**ADDENDUM # 2**  
Warren County Bridge Replacement  
Bridge #0570020 2  
12/8/2021

Warren County Bridge #0570020 1

**SECTION A-A**  
(N.T.S.)

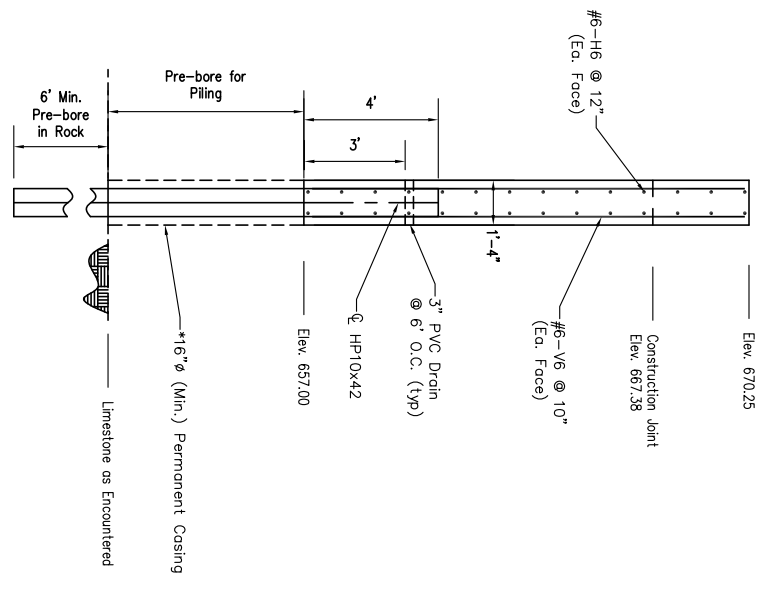
Please utilize the attached Bidding Form for bidding purposes. Also, replace Sheet 11 of 18 with the attached details. Note the 18-inch minimum diameter of permanent casing for HP12x53. Larger casing may be used for 16" and 18" diameter casing should it be deemed more economical based on equipment and/or material availability.

\*Permanent casing not required should no void be encountered (as indicated in Boring B-2).  
Larger casing may be used should it be deemed more economical based on equipment and/or material availability.
